Re: US 27 Tires, LLC
Facility ID: 101295
Polk County

**Florida Department of
Environmental Protection
Inspection Checklist**

Routine Operation Inspection for WPF - Waste Tire Processing Facility

Tire Racks Along NW Wall

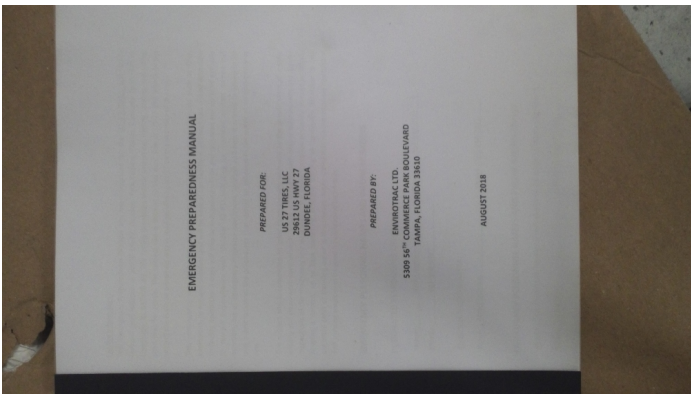
Explanation: During the inspection, waste tires were observed to not be stored in accordance with the facility's approved application documents including the Figure #2 Building Detail Plan and Facility Operations Plan received by the Department on October 8, 2018. Mr. Belfakir indicated that the facility has recently installed additional tire storage racks along the North Western exterior wall in order to increase storage capacity at the facility.

On March 9, 2020, Mr. Steve Morgan (Solid Waste Permitting) conducted a follow up site visit of the facility. During the site visit, Mr. Belfakir indicated that he would provide additional information regarding the current configuration of the new tire racks and how this impacts storage capacity on site.

Corrective Action: Please provide the information as noted above. Additionally, please note that a permit modification will be required following receipt and review of this information.
